## **RIDGELAWN SUBDIVISION, RESUBDIVISION OF**

### **LOT 1**

APPLICATION NUMBER 3 DATE March 18, 2021

REQUEST Subdivision

# DETAIL SITE PLAN

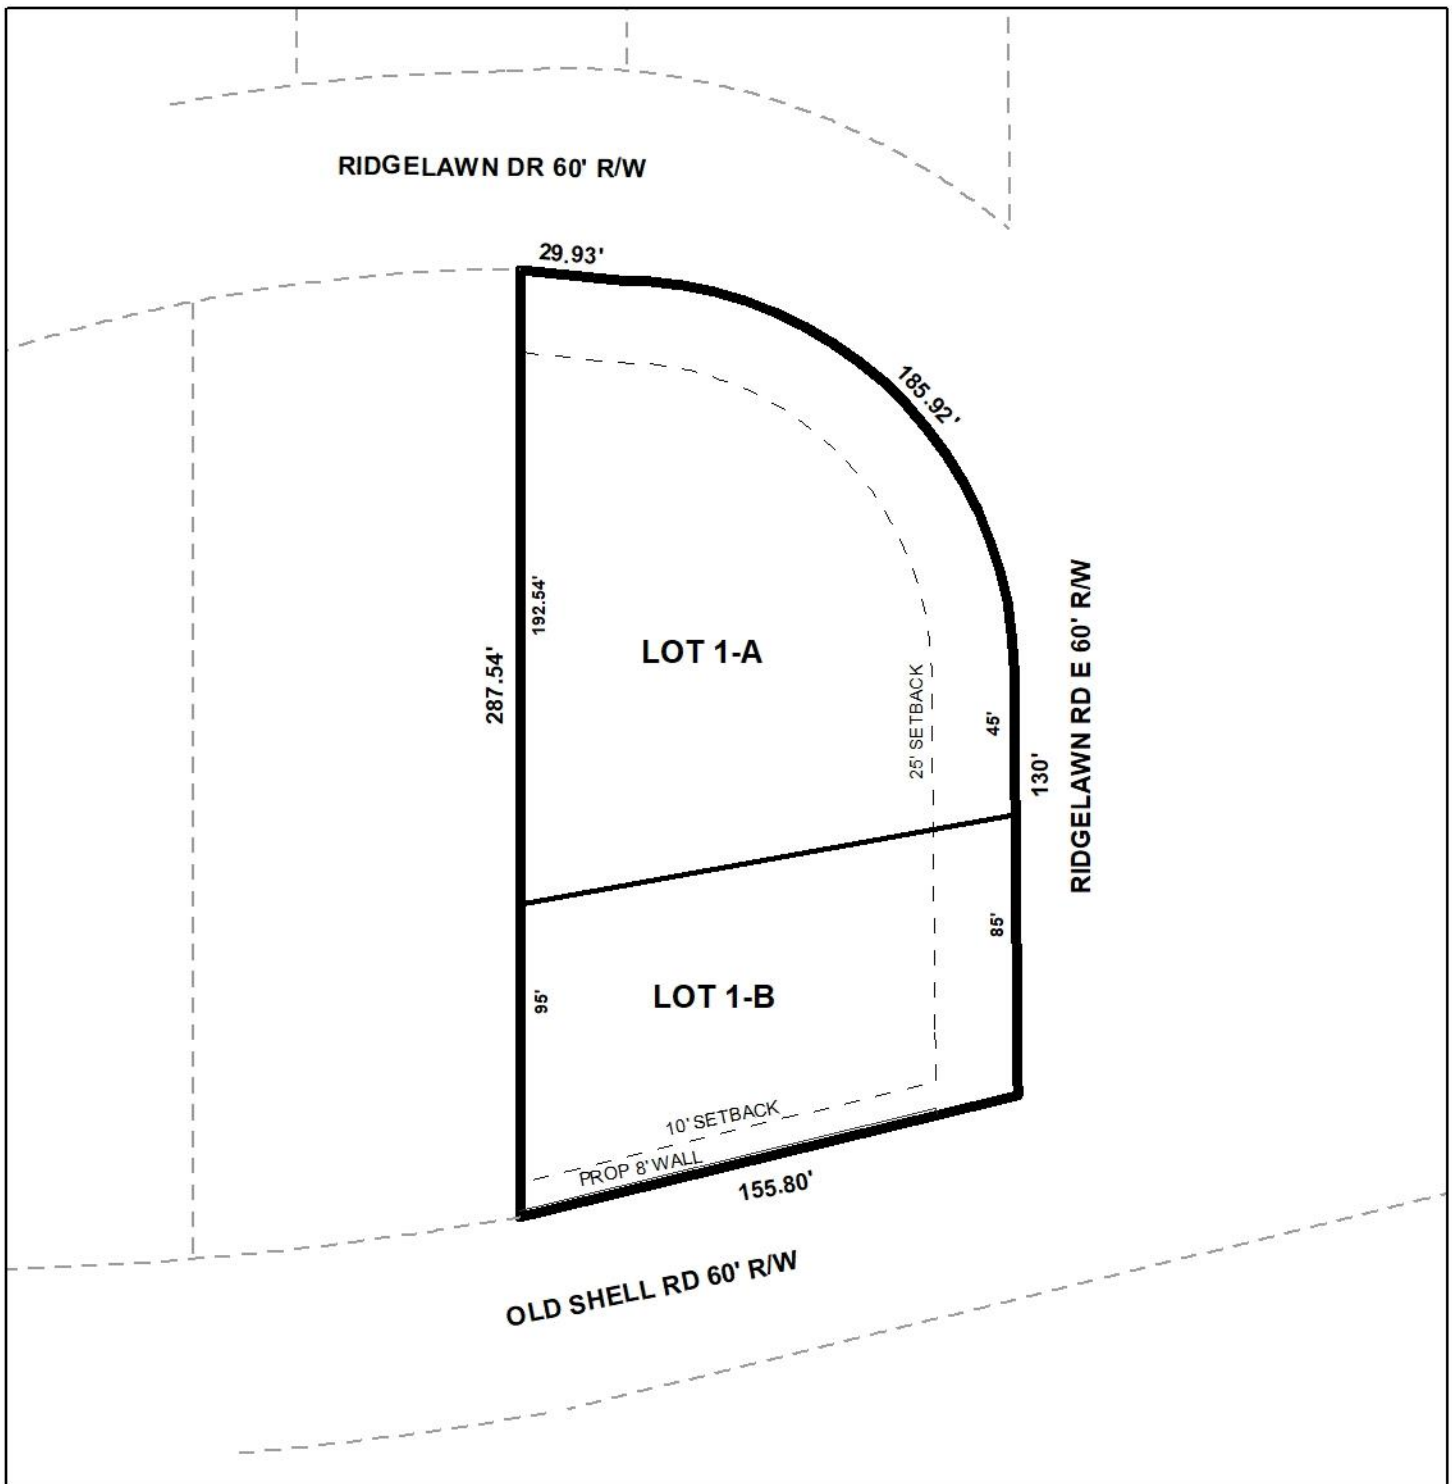
The site has frontage along Ridgelawn Drive East, Ridgelawn Drive, and Old Shell Road. All are minor streets with compliant 60-foot rights-of-way; therefore, no frontage dedication would be required. However, a 25-foot street corner radius should be dedicated at the intersection of Old Shell Road and Ridgelawn Drive East. As on the preliminary plat, the right-of-way widths should be retained on the Final Plat, if approved. The 25-foot minimum building setback line along Ridgelawn Drive East and Ridgelawn Drive should be retained on the Final Plat.

As the plat indicates a ten-foot minimum building setback line along Old Shell Road instead of the normal 25-foot, a Setback Variance will be required from the Board of Zoning Adjustment to allow the reduced setback; this should be done prior to signing the Final Plat. The preliminary plat also indicates a proposed eight-foot wall directly on the property line along Old Shell Road. An additional Variance would also be needed from the Board of Zoning Adjustment to allow the wall. The applicant has submitted such variance requests which are scheduled to be heard at the Board's April 5<sup>th</sup> meeting. As there is an automatic 15-calendar-day waiting period for appeals following any decision by the Board, the Final Plat cannot be signed before this waiting period has expired, if the subdivision is approved.

The plat should be revised to label the lot sizes in both square feet and acres on the Final Plat, after any required dedication, or a table should be furnished on the Final Plat providing the same information.

As per the Traffic Engineering comments, Lot 1-B is denied access to Old Shell Road and limited to one curb cut to Ridgelawn Drive East. Lot 1-A is limited to no more than one curb cut per street frontage. Driveway size, location and design to be approved by Traffic Engineering and conform to AASHTO standards. A note should be placed on the Final Plat stating these comments.

- 1) retention of the right-of-way widths of all adjacent streets on the Final Plat;
- 2) dedication to provide a 25-foot corner radius at the intersection of Old Shell Road and Ridgelawn Drive East;
- 3) retention of the 25-foot minimum building setback line along Ridgelawn Drive East and Ridgelawn Drive on the Final Plat;
- 4) retention of the ten-foot minimum building setback line along Old Shell Road, or whatever reduced setback is approved by the Board of Zoning Adjustment, or revision of

the plat to indicate a 25-foot minimum building setback line along Old Shell Road if the Setback Variance request is not approved;

- 6) retention of the lot size labels in both square feet and acres on the Final Plat, adjusted for any required dedication, or the furnishing of a table on the Final Plat providing the same information;

- 8) placement of a note on the Final Plat stating the Traffic Engineering comments: *(Lot 1-B is denied access to Old Shell Road and limited to one curb cut to Ridgelawn Drive East. Lot 1-A is limited to no more than one curb cut per street frontage. Driveway size, location and design to be approved by Traffic Engineering and conform to AASHTO standards.);*
